BEFORE THE ELECTRIC GENERATION AND TRANSMISSION SITING BOARD

ELECTRONIC APPLICATION OF)
THOROUGHbred SOLAR, LLC FOR A)
CERTIFICATE OF CONSTRUCTION FOR)
AN APPROXIMATELY 50 MEGAWATT) Case No. 2022-00115
MERCHANT ELECTRIC SOLAR)
GENERATING FACILITY IN HART)
COUNTY, KENTUCKY PURSUANT TO)
KRS 278.700 AND 807 KAR 5:110.)

**THOROUGHbred SOLAR, LLC'S RESPONSES TO THE KENTUCKY
ELECTRIC GENERATION AND TRANSMISSION SITING BOARD'S
FIRST REQUEST FOR INFORMATION**

Exhibit D
Facility Location With
Residential Neighborhoods

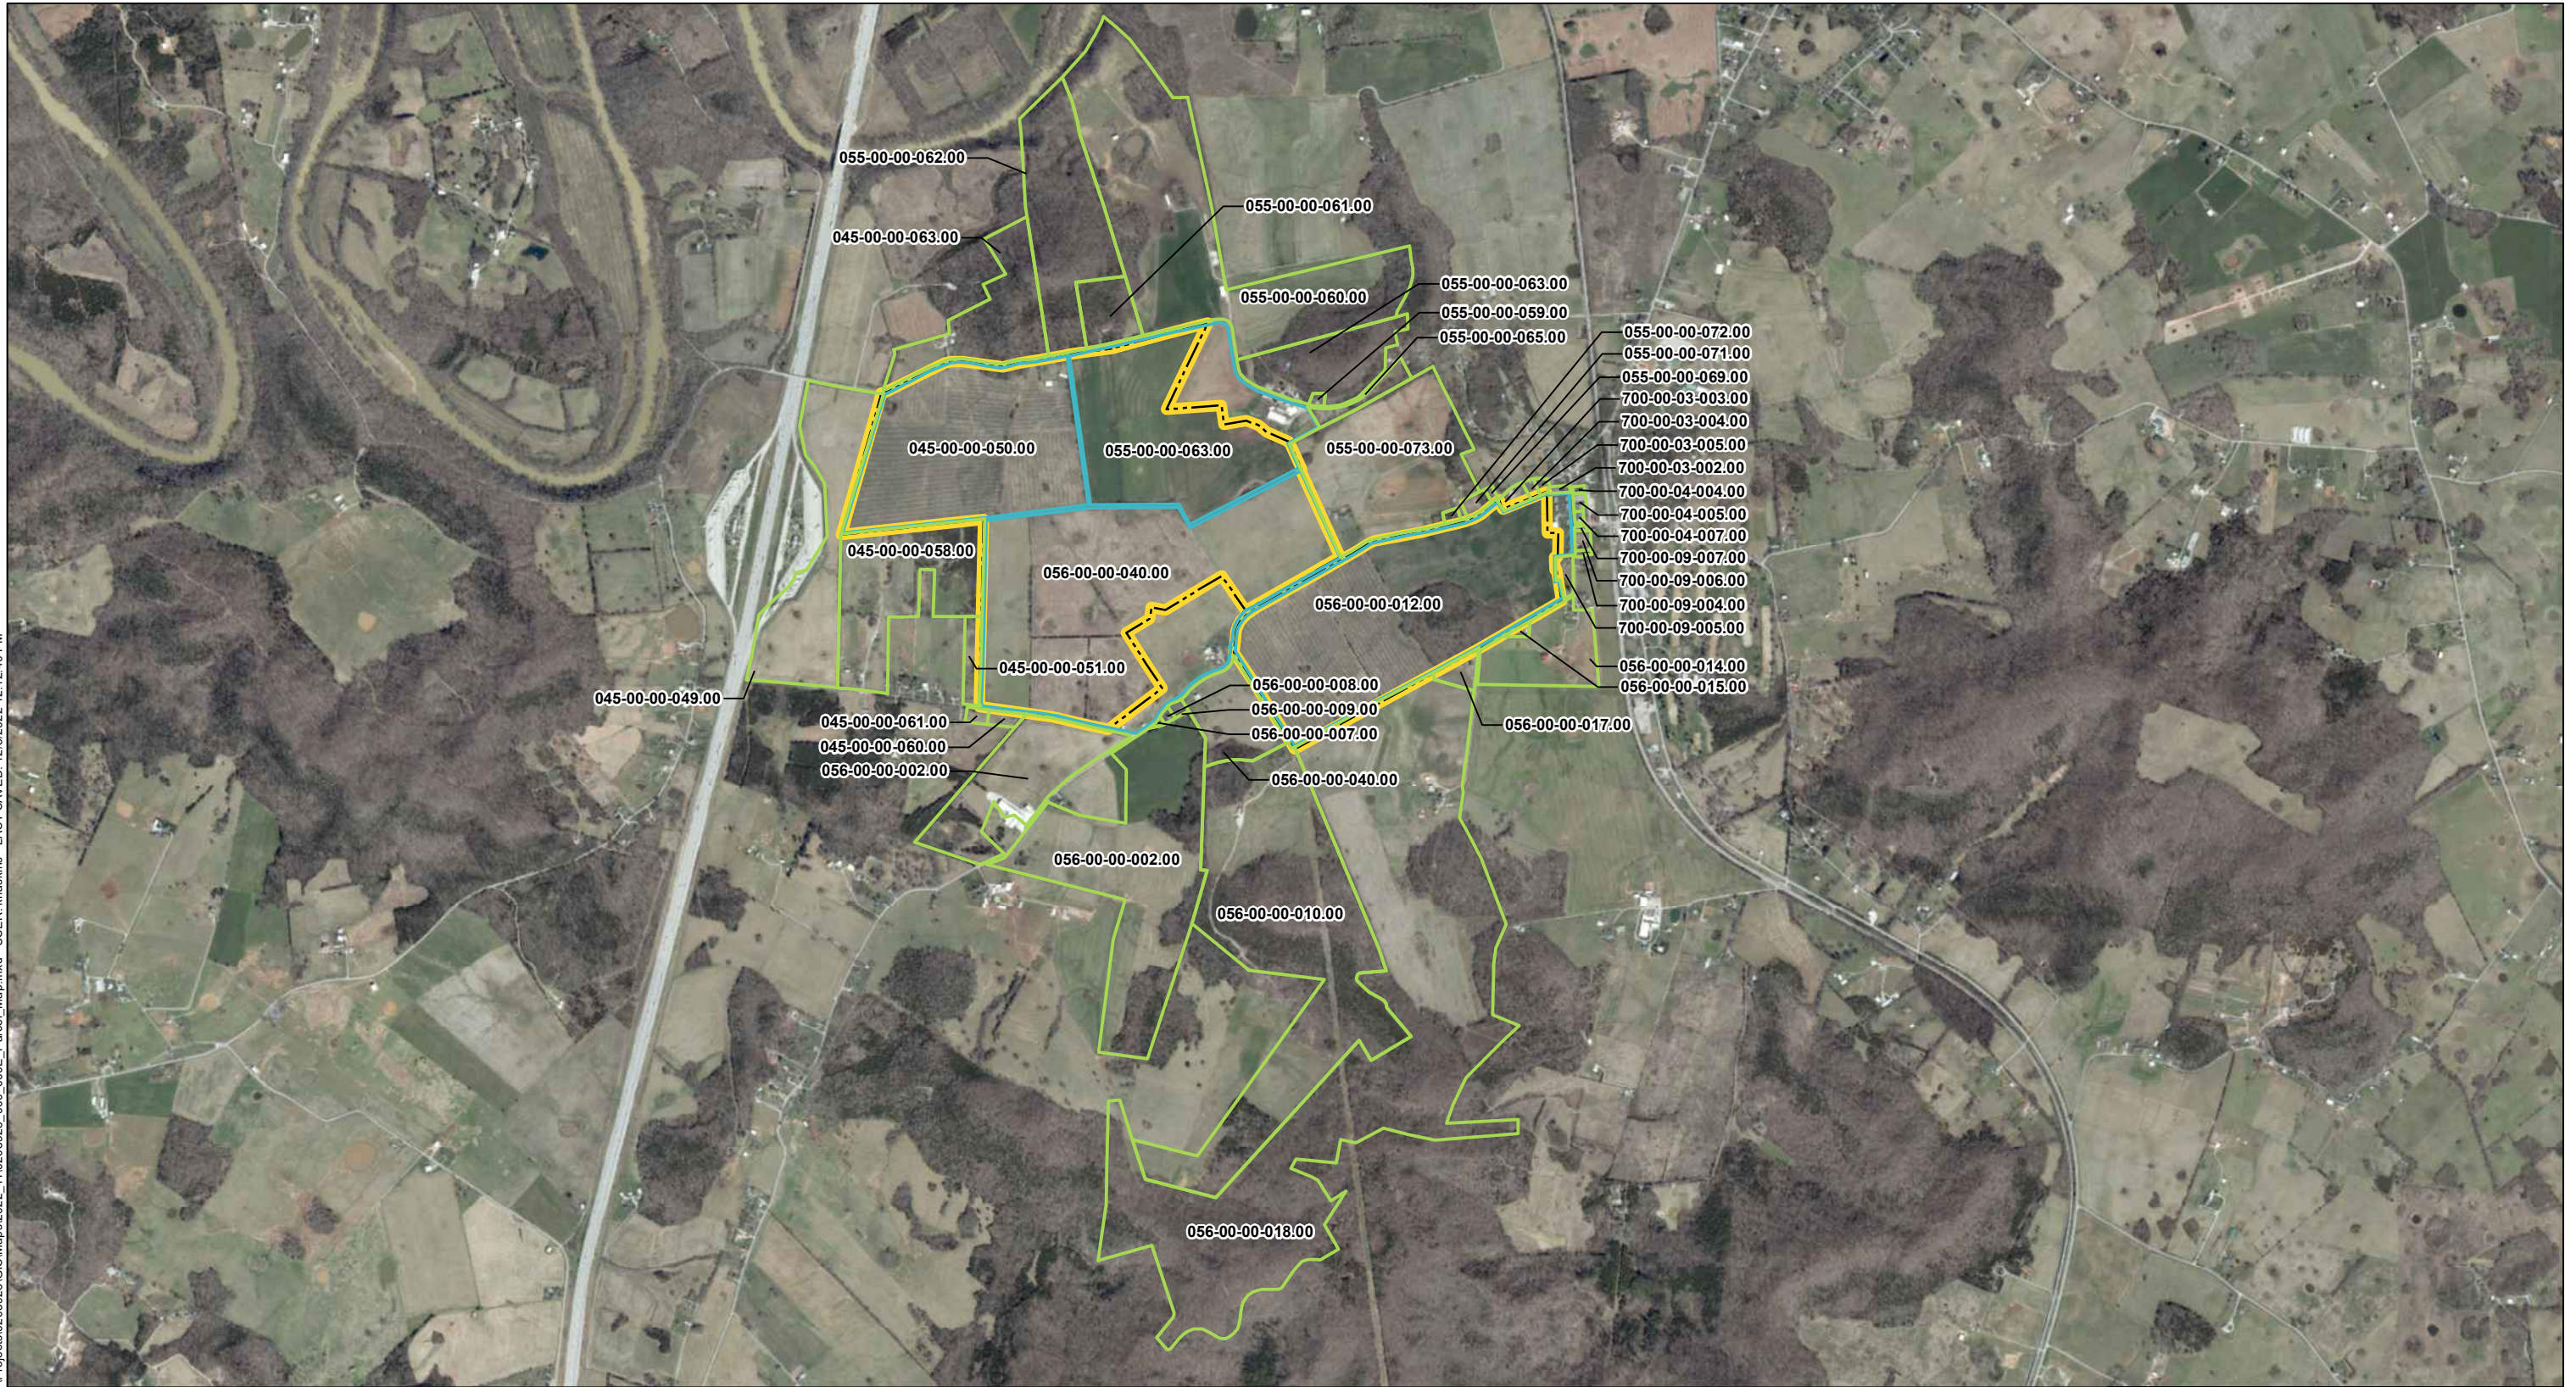
10. For any residential structures within 2,000 feet of the project boundary provide a table listing each of the following.
- a. The distance to the boundary line.
 - b. The distance to the closest solar panel.
 - c. The distance to the nearest inverter.
 - d. The distance to the nearest inverter.

RESPONSE: For purposes of this response, Applicant assumes request No. 10d above intended to request the distance from the substation; as for Response 9, the closest distance to the entire substation/switchyard area has been provided. The attached Exhibit D provides

a key map identifying the requested information relative to both residences within a “Residential neighborhood” as defined in KRS § 278.700(6) and within 2,000 feet but not within a “Residential neighborhood.” Note that the closest residences shown within “Residential neighborhood 1” (as shown on Exhibit D) are rental units on property owned by a participating landowner.

**Exhibit E
Parcel Map**

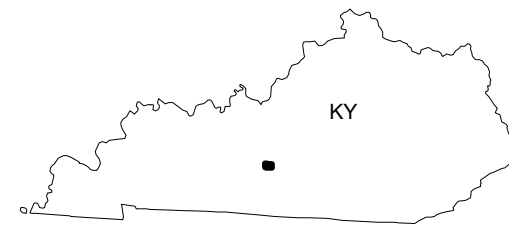
13. Provide a map identifying each project property and adjacent property by its APN.

RESPONSE: See the attached Exhibit E, which shows the parcel identification.
